Conlin Properties - 3710 Hubbell Avenue

Communication from the City Plan and Zoning Commission advising that at their meeting held October 18, 2012, the following action was taken regarding a request from Conlin Properties, Inc.(purchaser) represented by James Conlin (officer) to rezone property located at 3710 Hubbell Avenue from "C-2" General Retail and Highway Oriented Commercial District and "R1-80" One-Family Residential District to "PUD" Planned Unit Development District.

**APPROVAL** of Part A) to find the requested rezoning is in conformance with the Des Moines' 2020 Community Character Plan future land use designations of Commercial: Auto-Oriented Small-Scale Strip Development and Medium Density Residential; Part B) to approve the proposed rezoning from "C-2" General Retail and Highway Oriented Commercial District and "R1-80" One-Family Residential District to "PUD" Planned Unit Development District; and Part C) to approve the proposed PUD Conceptual Plan for Hilltop Apartments, subject to the following revisions: (ZON2012-00172)

ZON2012-00172

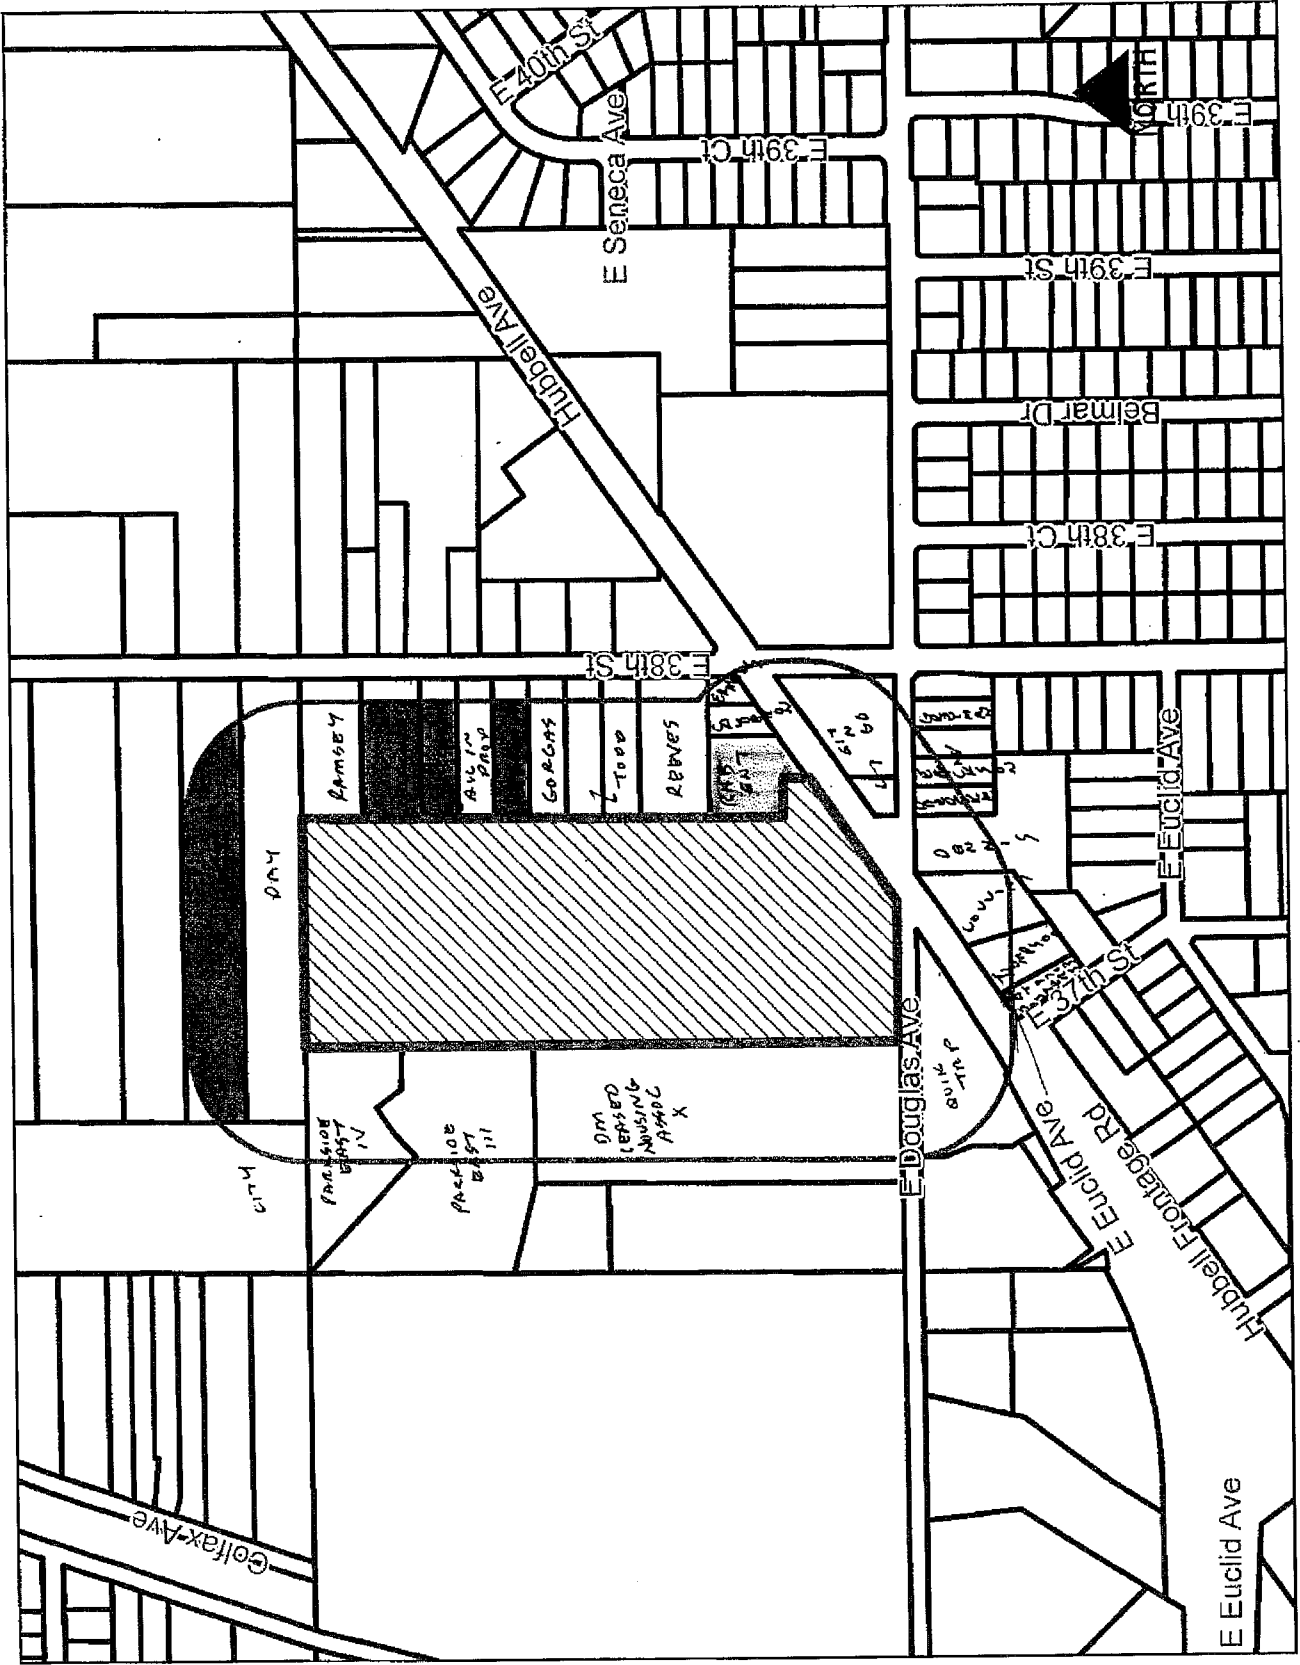
Part C) Staff recommends approval of the proposed PUD Conceptual Plan for Hilltop Apartments, subject to the following revisions:

- 39
1. The notes regarding the buffer be revised to state the buffers along the north and east property lines will include a 20-foot wide buffer containing a 6-foot tall solid wood fence, at least 4 overstory trees, and a mix of at least 8 additional evergreen, ornamental, or overstory trees.

2. The note regarding the required traffic study shall be clarified to state that the traffic study will include trip generation and distribution estimates for the proposed development, including analysis of the impact on the surrounding street system. The layout of the PUD Conceptual Plan is preliminary only and, based on the findings of the traffic study, driveway locations may be required to be altered, and turn lanes and/or traffic signals may be required. If the Development Plan is significantly different than the PUD Conceptual Plan, the PUD Conceptual Plan may have to amended.

3. The 30-foot building setback line along Hubbell shall be shifted 15 feet to accommodate the demonstrated 15 feet of future Hubbell Avenue right-of-way.

4. Provision of the following note: In accordance with IFC Section 508.5.1; where a portion of the facility or building hereafter constructed or moved into or within the jurisdiction is more than 400 feet from a hydrant on a fire apparatus access road, as measured by an approved route around the exterior of the facility or building, on-site fire hydrants and mains shall be provided (Exception: R-3, U & sprinklered buildings shall be no more than 600 feet from a hydrant).

5. The PUD Conceptual Plan shall indicate that vinyl shall not be a permitted material for the proposed horizontal overlap siding.
  6. The PUD Conceptual Plan shall indicate that all balconies on the multiple-family residential structures shall be constructed with predominantly metal materials.

7. The PUD Conceptual Plan shall include the elevations for all facades of the multiple-family residential structures to the satisfaction of the Planning Director.

8. The PUD Conceptual Plan shall include a typical elevation of a two-family dwelling to the satisfaction of the Planning Director. The elevations shall include brick and siding materials compatible with the proposed elevation for the one-family dwellings.

9. The PUD Conceptual Plan shall include conceptual elevations of the proposed accessory structures (clubhouse, fitness center, computer center, etc) to the satisfaction of the Planning Director. The elevations shall include brick and siding materials compatible with the primary structures.
